Notes for Presentation / Supplement to Comments

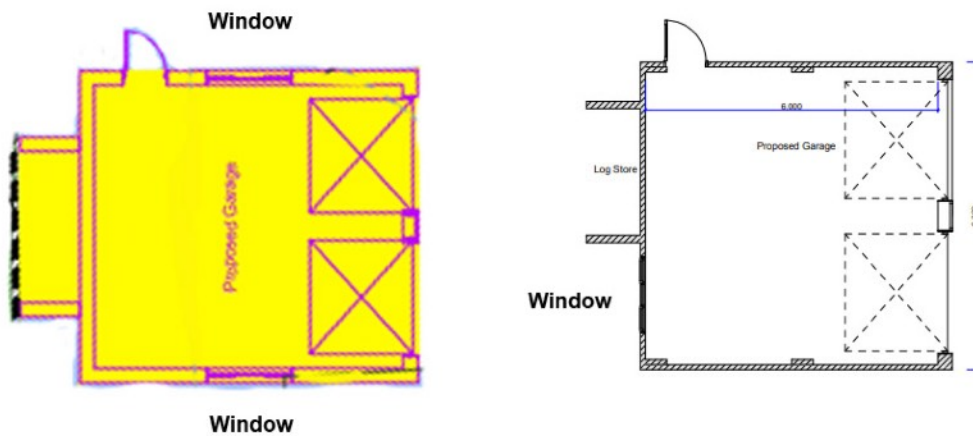
Difference in drawings of position of and quantity of windows in proposed garage; and position of log store

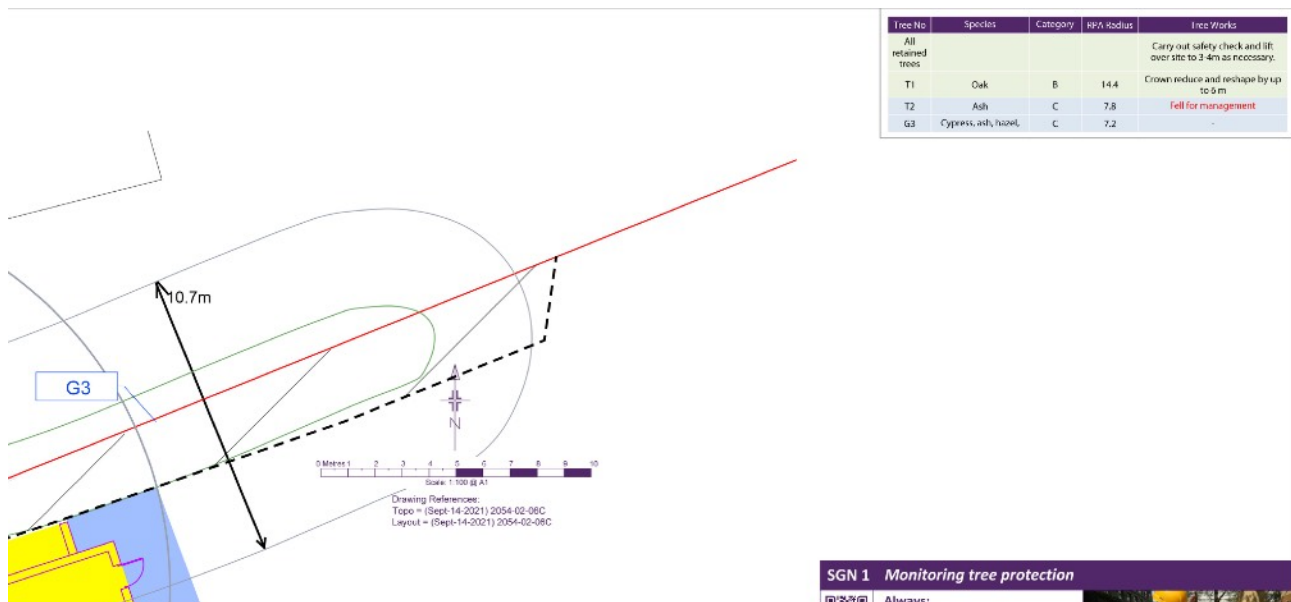
The Tree Protection Drawing shows an incorrect detail for the RPA of G3. Both the Arboricultural Assessment and the Tree Protection drawing refer to a RPA radius of 7.2. However the drawing is more like 5.35m (see below where I have measured the diameter at 10.7m ie a radius of 5.35m from using the scale). Thus the drawing shows a significantly smaller RPA for G3 than it should.

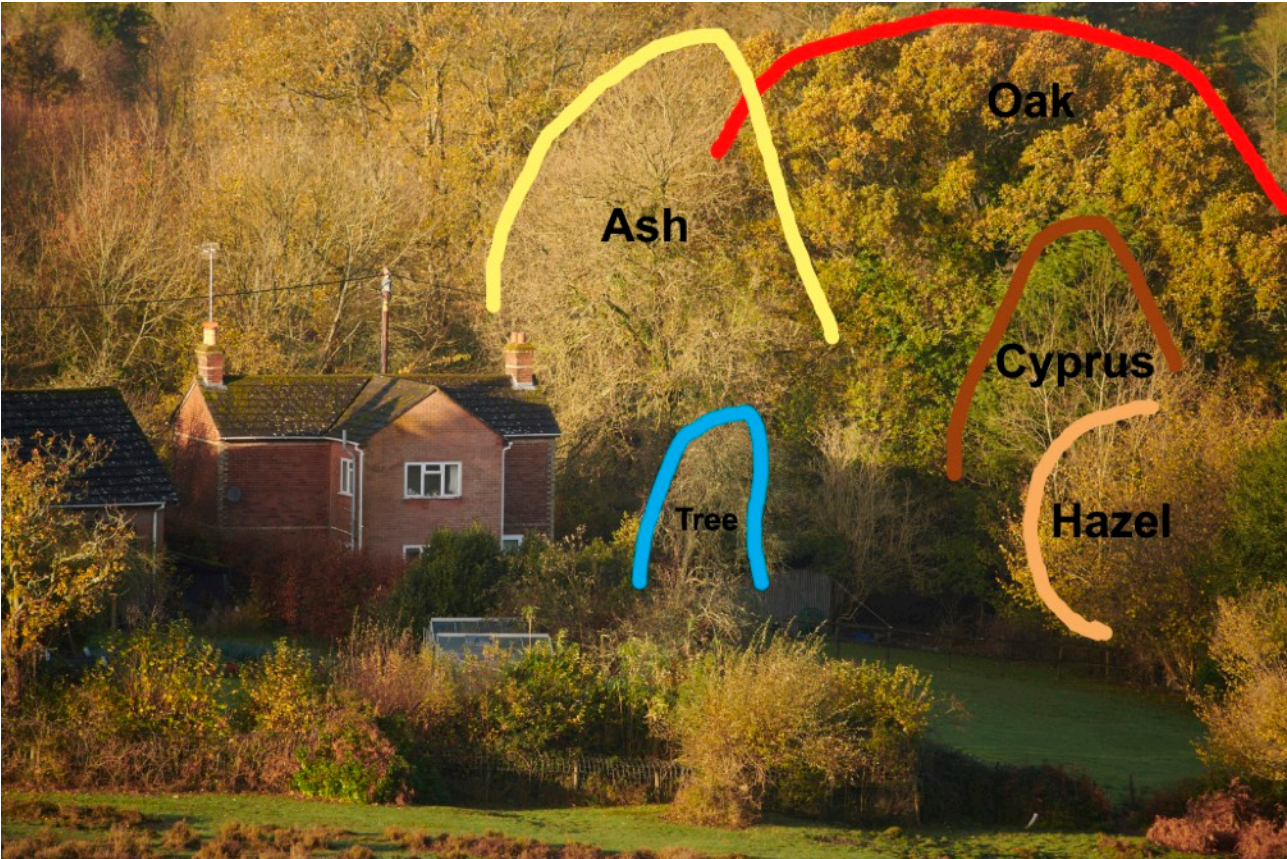
The application does not show an elevation containing both the proposed dwelling and garage. In order for the garage to minimise damage to the roots it will be on piles with a gap between the existing levels and the base of the proposed garage.

The slope estimated to be an angle of 6.5 degrees, and with a minimum gap between base and ground level of 100mm, would result in a height of approximately 1m at its furthest extent.

Thus stairs and landing to access side door and log-store will be required. These are not shown on the application.

Photo 5: Tree T2, a low-quality ash to be removed. The yellow line indicates the approximate extent of crown reduction required to tree T1 as a result of historic storm damage.

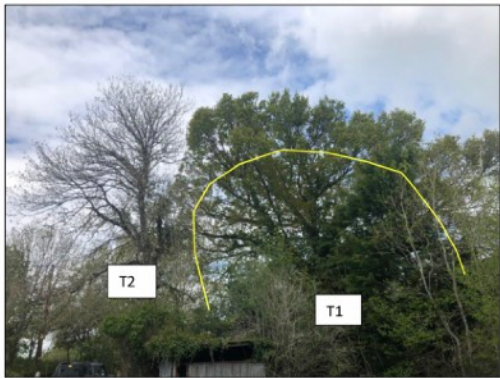
Significant destruction of Oak leaving it as little more than a trunk - 6m cut off; more than is required to make it safe from falling branches - branches that are dangerous should be identified

Arboricultural Assessment shows at most 2m off the crown whereas the proposal as per the Tree Protection plan would be to take 6m off

Cattle Grid

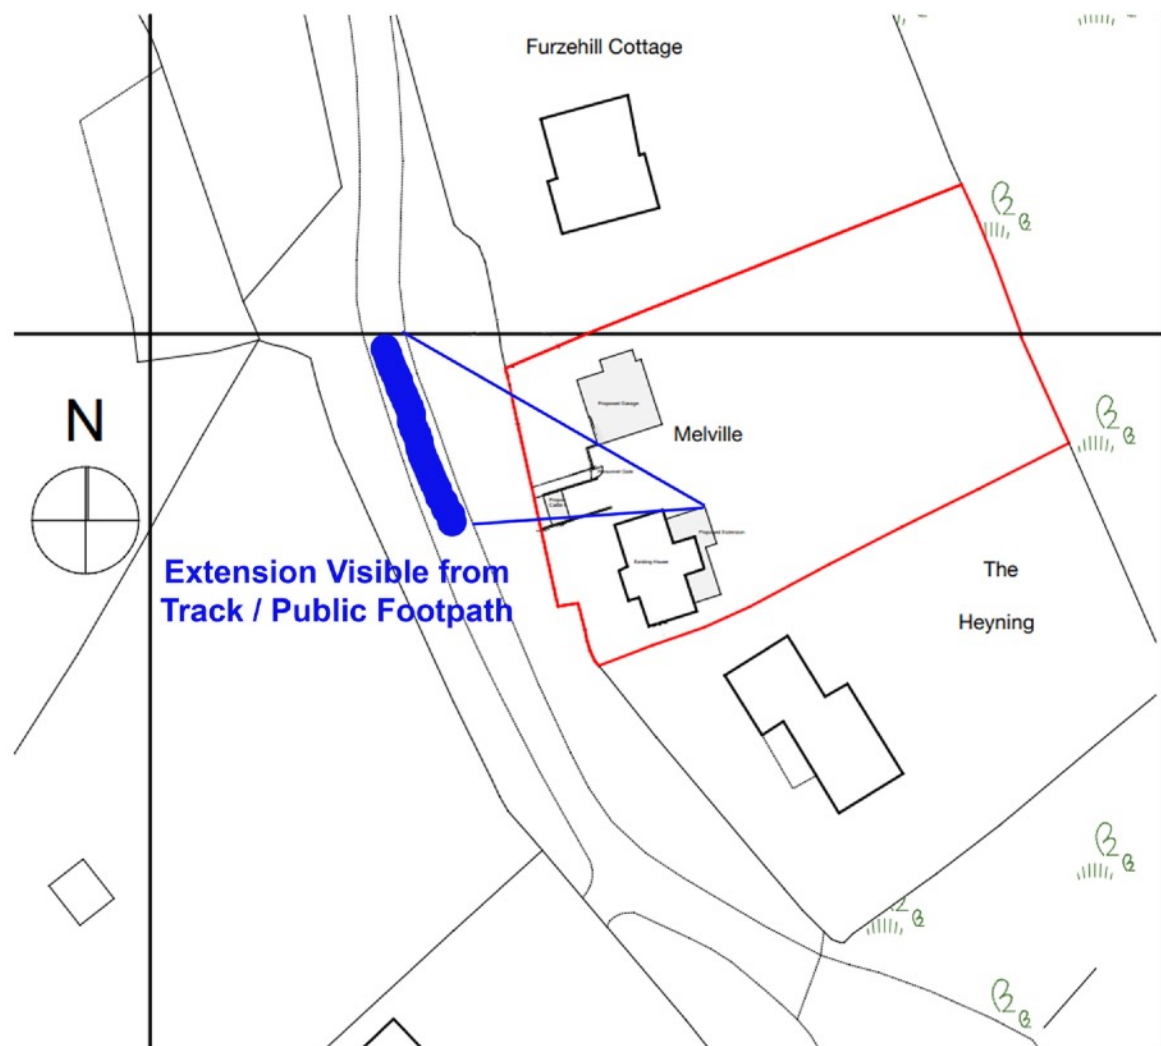
The cattle grid will widen access, damage RPA, create unnecessary noise with vehicles crossing it, without animal ramp trap small animals when they fall in, is shown with pedestrian side entrance in addition to the one to the front door.

No overriding justification has been given for a cattle grid rather than a gate and under BS 5837 should not be allowed.
